Conceptual Zoning Site Plan

Cumberland Parkway Site - Cobb County, GA

PETITION NO: Z-93

ZONING COMMENTS:

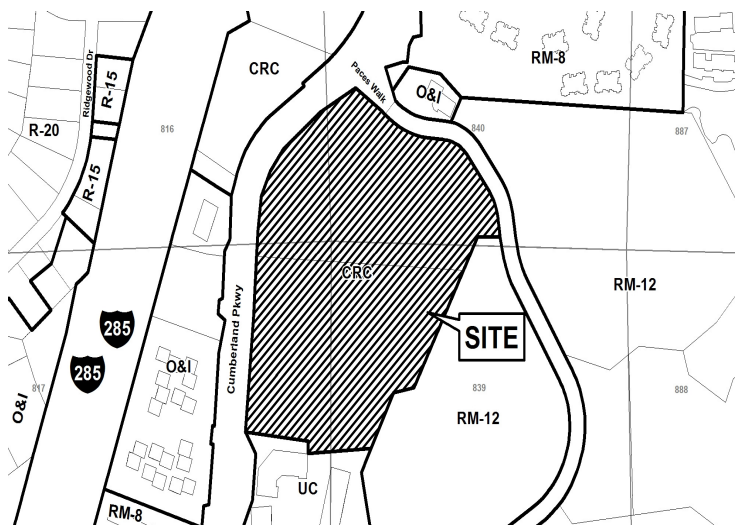
The proposed plan will require a contemporaneous variance to waive the front setback from the required 50 feet to 25 feet. The applicant also needs to reduce the 50-foot landscape buffer along the east and south property lines to allow the access drives.

- Provide comprehensive hydrology/stormwater controls to include development of out parcels.
- Submit all proposed site improvements to Plan Review.
- Any **spring activity** uncovered must be addressed by a qualified geotechnical engineer (PE).
- Structural fill _____ must be placed under the direction of a qualified registered Georgia geotechnical engineer (PE).
- Existing facility.
- Project must comply with the Water Quality requirements of the CWA-NPDES-NPS Permit and County Water Quality Ordinance.
- Water Quality/Quantity contributions of the existing lake/pond on site must be continued as baseline conditions into proposed project.
- Calculate and provide % impervious of project site.
- Revisit design; reduce pavement area to reduce runoff and pollution.

- No Stormwater controls shown _____
- Copy of survey is not current – Additional comments may be forthcoming when current site conditions are exposed.
- No site improvements showing on exhibit.

1. Site plan received by the Zoning Division on August 4, 2016, with the District Commissioner approving minor modifications;
2. Variance requested in Zoning Comments section;
3. Water and Sewer Division comments and recommendations;
4. Stormwater Management Division comments and recommendations; and
5. Department of Transportation comments and recommendations.
